Access Compliance Report

Public Rights-of-Way

(Curb Ramps)

Intersection ID: N/A	Main Street: S BREVARD ST	Cross Street: E 3RD ST	Location: W
ADA ID: 08828D6ED711	Ramp Type: Perp	Initial Pass/Fail: Fail	Overall Compliance: No
		Severity Score: 12.5

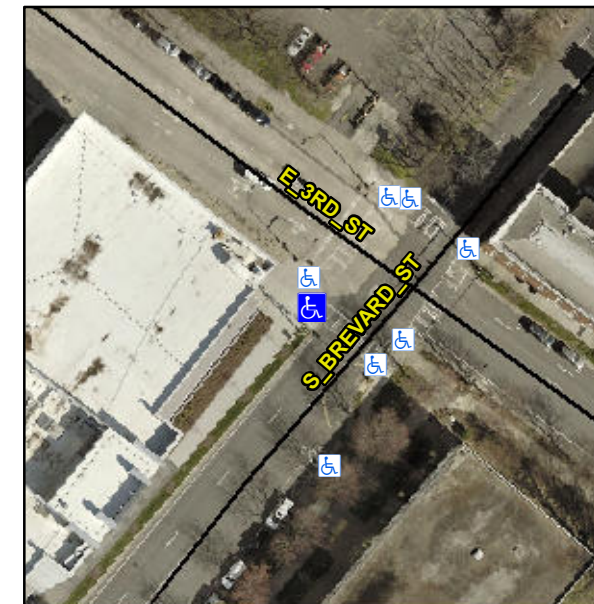
Not Found, R304.2.2

Compliance	Description	Data	Compliance	Description	Data
N/A	Ramp Length (in)	70.0	No	Ramp Slope (%)	10.3
Yes	Ramp Width (in)	48.0	Yes	Ramp XSlope (%)	0.3
N/A	Flare Type LT	N/A	N/A	Flare Type RT	N/A
N/A	Flare Slope LT (%)	N/A	N/A	Flare Slope RT (%)	N/A
N/A	Flare Traversable LT?	No	N/A	Flare Traversable RT?	No
N/A	Landing Length (in)	N/A	N/A	DWS Provided?	N/A
N/A	Landing Width (in)	N/A	N/A	DWS Contrast?	N/A
N/A	Landing Slope (%)	N/A	N/A	DWS Length (in)	N/A
N/A	Landing X Slope (%)	N/A	N/A	DWS Full Width?	N/A
N/A	Landing Curb? (Y/N)	N/A	N/A	DWS Offset (in)	N/A
N/A	Shared Landing?	N/A			
N/A	Gutter Ponding?	N/A	N/A	Gutter Slope (%)	N/A
N/A	Gutter Lip Ht (in)	N/A	N/A	Gutter X Slope (%)	N/A
N/A	Painted X Walk1?	Yes	N/A	Painted X Walk2?	N/A
	X Walk 1 Direction	To SE		X Walk 2 Direction	N/A
N/A	X Walk 1 Width (in)	104.0	N/A	X Walk 2 Width (in)	N/A
	X Walk 1 Slope (%)	5.4		X Walk 2 Slope (%)	N/A
	X Walk 1 X Slope (%)	0.9		X Walk 2 X Slope (%)	N/A

Remove & Replace Entire Ramp.
